## **ADDENDUM NO. ONE (1)**

**ITB #2-2018/2019 Gulf Coast State College  
20<sup>th</sup> Street Realignment**

**Dewberry Project Number: 50094809**

**August 27, 2018**

**FIBER OPTIC  
ROUTE EXHIBIT**

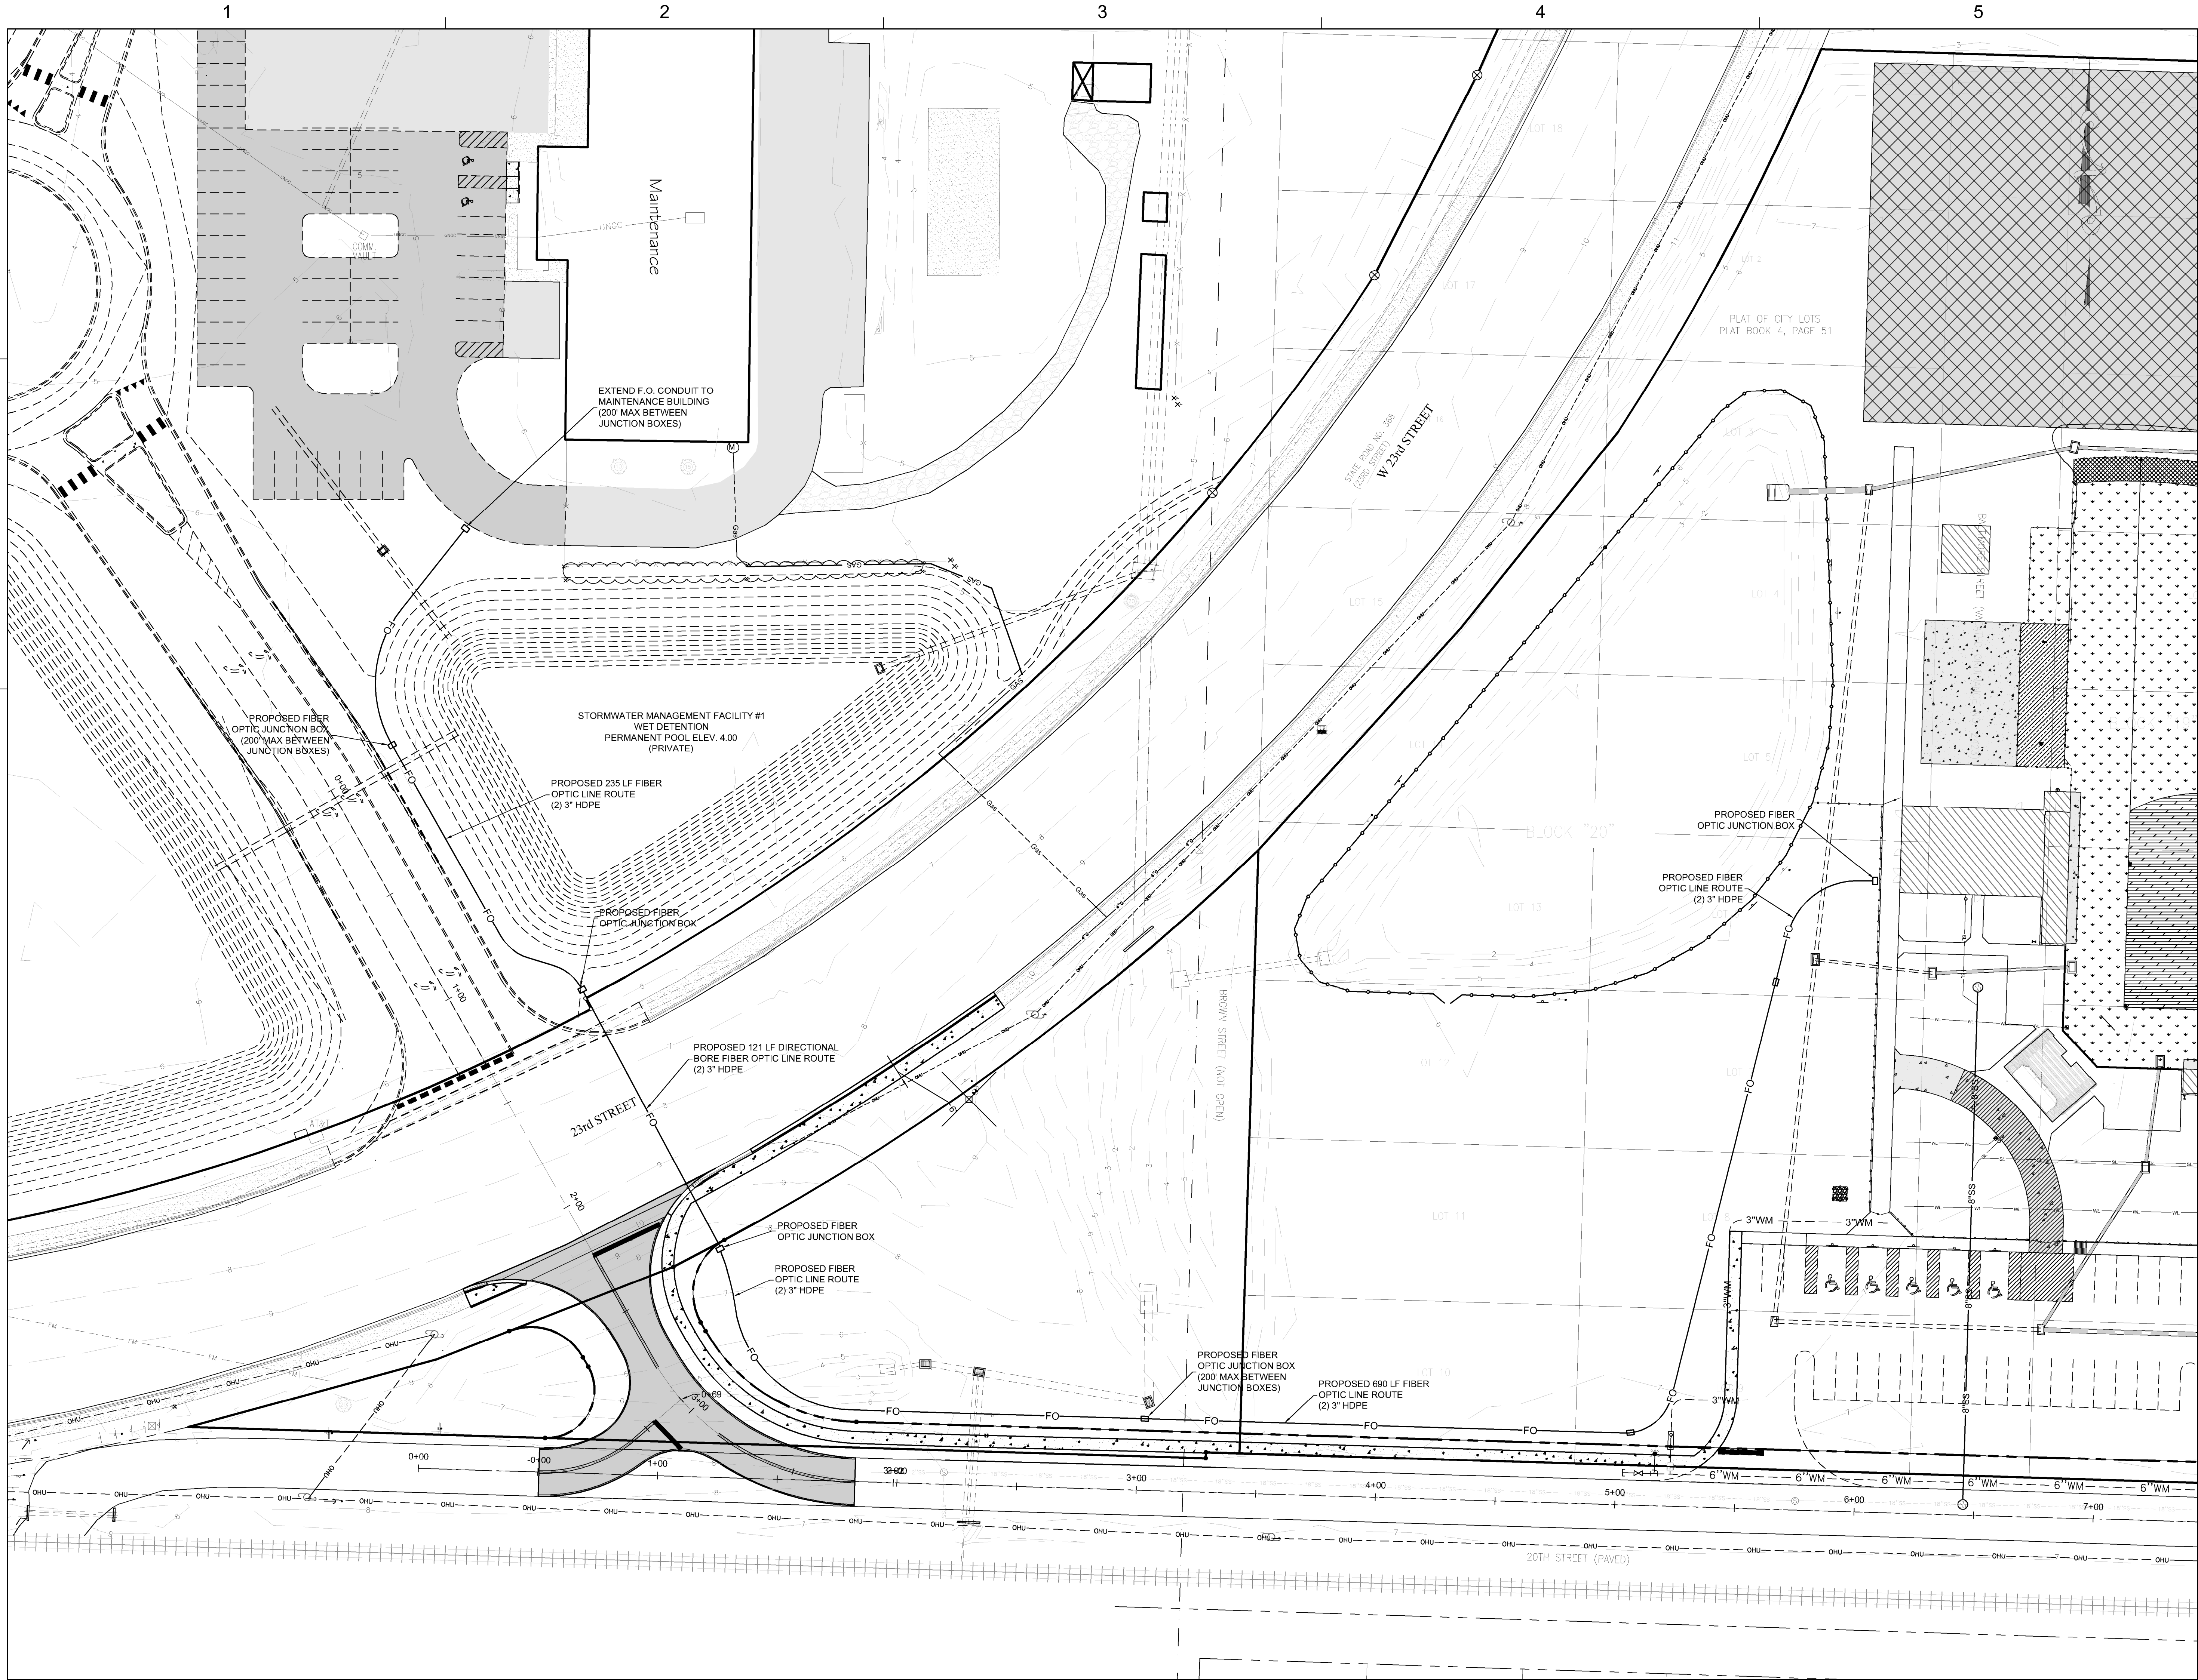
The scope of work for the fiber optic line will be limited to providing 2-3" HDPE conduits and junction boxes extending from the maintenance building to the softball field office. Fiber optic cable is not included.

Base proposal cost for fiber optic conduit on the following quantities:

- 1) 235 linear feet of 2-3" HDPE conduits from GCSC maintenance building to start of bore on north side of 23rd Street ROW
- 2) 121 linear feet directional bore of 2-3" HDPE conduits across 23rd Street ROW
- 3) 690 linear feet of 2-3" HDPE conduits from end of bore on the south side of 23rd Street ROW along 20th Street to the GCSC softball field office.
- 4) 8 fiber optic conduit junction boxes
